Appendix C Stage 1 Road Safety Audit and Engineer's Response

STAGE 1 ROAD SAFETY AUDIT

Scheme – Macclesfield Road realignment SEMMMS A6 to Manchester Airport Relief Road

SEMMMS A6 to Manchester Airport Relief Road Engineers Response to Stage 1 Road Safety Audit – Macc Rd Jct

Appendix B Macclesfield Road Realignment Proposals (1007_3D_DF7_A6-MA_GA_MR_335_C)

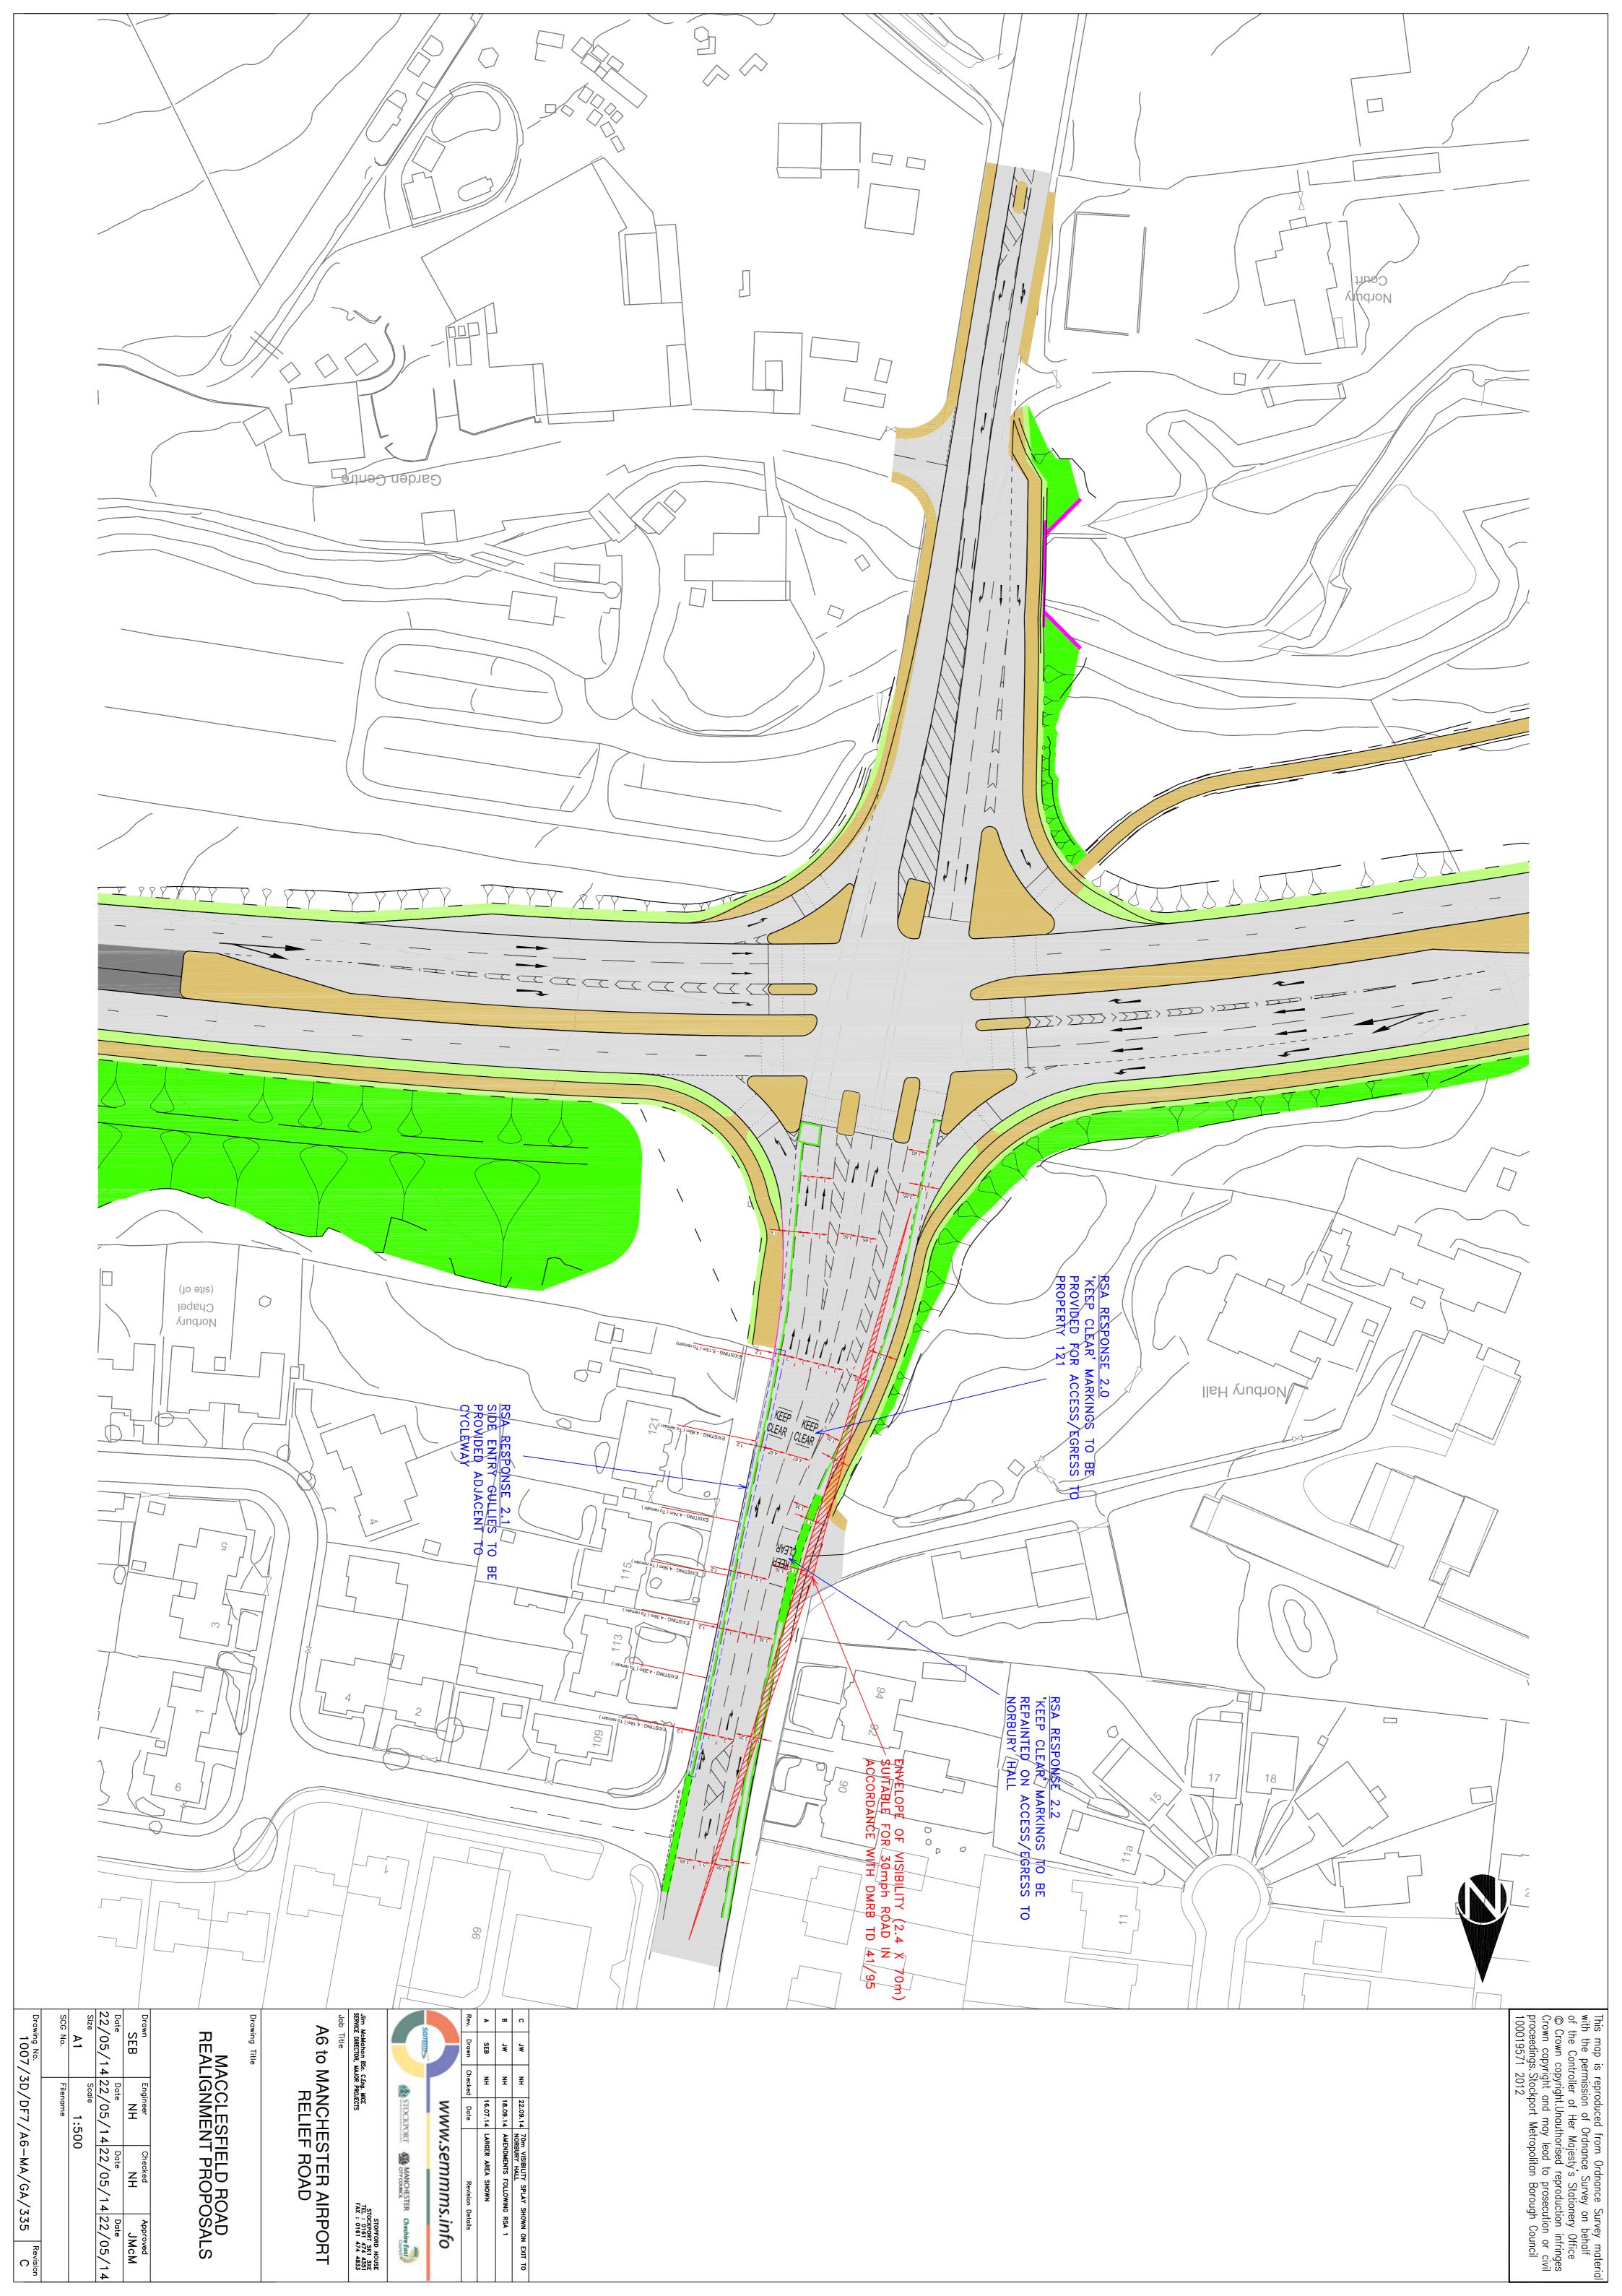
Problem 1

Macclesfield Road access / egress to property 121

Access to and from property 121when turning right will involve crossing 12 metres of carriageway (plus cycle lane). Whilst the southbound lanes are marked as two; at this width of carriageway it is conceivable that four lanes of traffic could be formed. In addition, with a predicted increase of 19% in traffic flows this could potentially lead to congestion problems and collisions for turning traffic.

Whilst it is accepted that the demand for turning will be low from a residential property it is difficult to assess the degree of risk associated with turning right across three / four lanes of moving traffic. It is recommended that accident records of similar road layouts be assessed to ascertain whether this layout presents an unacceptable level of risk. A reduction in the southbound carriageway width would restrict the number of lanes of traffic that would be able to form and therefor reduce the level of risk.

Problem 2

Southbound Cycle Lane

At 1.2 metres wide the southbound cycle lane is sub-standard and could lead to an increase in vehicle / pedal cyclist collisions

It is recommended that the cycle lane should be 1.5 metres wide.

Observation A

Macclesfield Road / Norbury Hall access

There are 'keep clear' markings at the entrance to the access road which indicates that there have been problems with queuing traffic blocking the junction.

It is recommended that the 'keep clear' markings are retained within the new design proposals.

Response: The traffic modelling carried out on the Macclesfield Road Junction determined the queue lengths on the southbound approach to the junction. As a result this means that the length of the lanes cannot be amended and the lane widths outside property 121 cannot be reduced to allow a sufficient distance for 2 lanes to split in to 4 on the approach to the junction. Though we accept that the lane widths outside property 121 are wide (4.67m), we believe that vehicles turning right to access the property only have to cross 10 metres of carriageway (plus cycle lane). We will include 'Keep Clear' road markings across both lanes outside the property to allow better visibility for vehicles accessing the property.

Response: Existing kerb line outside Macclesfield Road properties have been amended following liaison with the residents it was agreed that none of the existing footway outside their properties would be taken. To provide suitable vehicle lane widths then a maximum

cycle lane width of 1.2m can be provided. Side entry gullies will also be provided on this section of the cycleway to give a useable width for cyclists.

Response: The existing 'Keep Clear' road markings outside the Norbury Hall access road will be repainted and widened to suit the proposed tie in to the access to the property.
